Joseph M. Farley Nuclear Plant – Unit 2
Vogtle Electric Generating Plant – Unit 1
Proposed Alternative for Application of
Full-Structural Weld Overlays on Pressurizer Nozzles

**Request for Alternative - ISI-GEN-ALT-07-01, Version 2.0
Application of Pressurizer Nozzle Full-Structural Weld Overlays**

**Response to Request for Additional Information
Regarding Request for Alternative, ISI-GEN-ALT-07-01, Version 1.0
Application of Pressurizer Nozzles Full-Structural Weld Overlays**

FIGURE 1: ACCEPTANCE EXAMINATION VOLUME

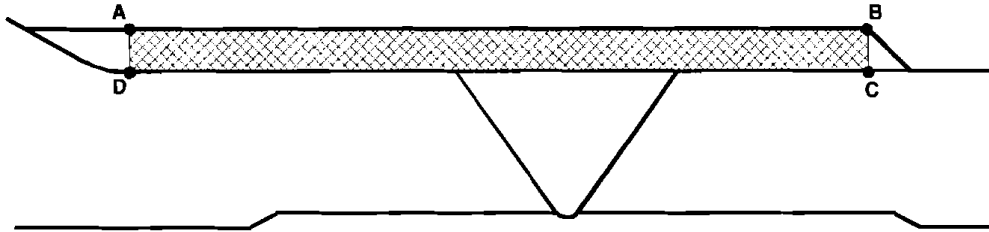
In Appendix 2, Figure 1, of Enclosure 1, the licensee presented 3 figures for weld overlay examination volume. However, in Section 3(a)(3) of ISI-GEN-ALT-07-01, Version 1.0, the licensee only referred to Figure 1a and not to Figures 1b and 1c. Also, Figures 1b and 1c were not discussed in other parts of the proposed alternative. Discuss why figures 1b and 1c are included in Appendix 2 if they are not being discussed in ISI-GEN-ALT-07-01, Version 1.0.

Figures 1b and 1c were removed. Figure 1a was then renamed as Figure 1. See ISI-GEN-ALT-07-01, Version 2.0 in Enclosure 1.
